## 1. Introduction

### 1.1 Purpose of the Groundwater Sustainability Plan

**Grassroots Coalition believes that the Draft GSP of the Santa Monica Subbasin to be out of compliance with the investigative requirements of SGMA and believes that the Groundwater Dependent Ecosystem elements of SGMA have been excluded in whole and/or in part pertaining to the BALLONA WETLANDS and the sw region of the Subbasin. The BALLONA WETLANDS ECOLOGICAL RESERVE, as well as the underlying regional freshwater aquifers known individually as the Ballona, Bellflower and Silverado Aquifers, which act in this region as one unit, were not meaningfully addressed and the GSA excluded readily available data made known to the GSA and requested for inclusion. Despite our repeated requests for inclusion of critically important data, the GSA consultant company response at the August GSA 2021 Meeting was,**

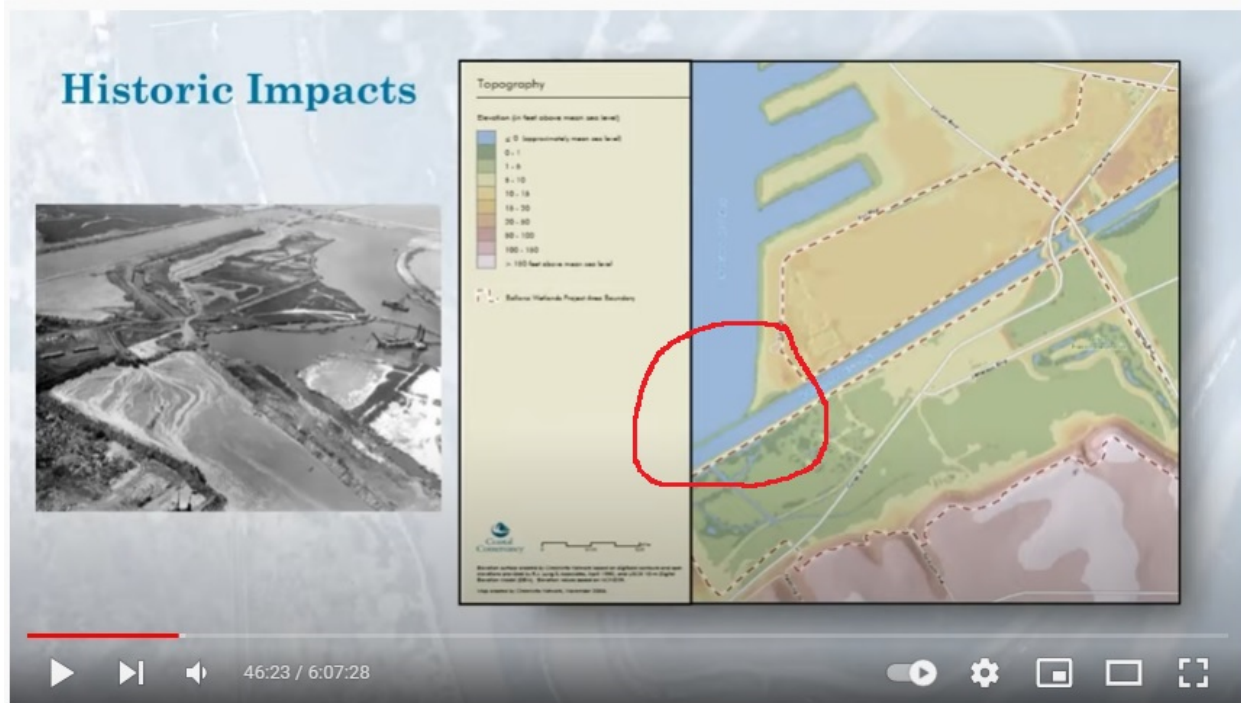
Additionally, replacement wells are planned by SCG. The FEIR shows the placement of these replacement wells within one to a few hundred feet of homes. While cities, state legislators and the public are working toward phasing out oilfield operations, drilling new wells and/or at least having a

2,000 foot buffer zone, the SoCalGas replacement wells' locations contradict current efforts towards safety. The following Links provide SoCalGas/Playa del Rey internal documents that verify contamination to the environment. A timeline of some of SoCalGas/Playa del Rey incidents is provided.
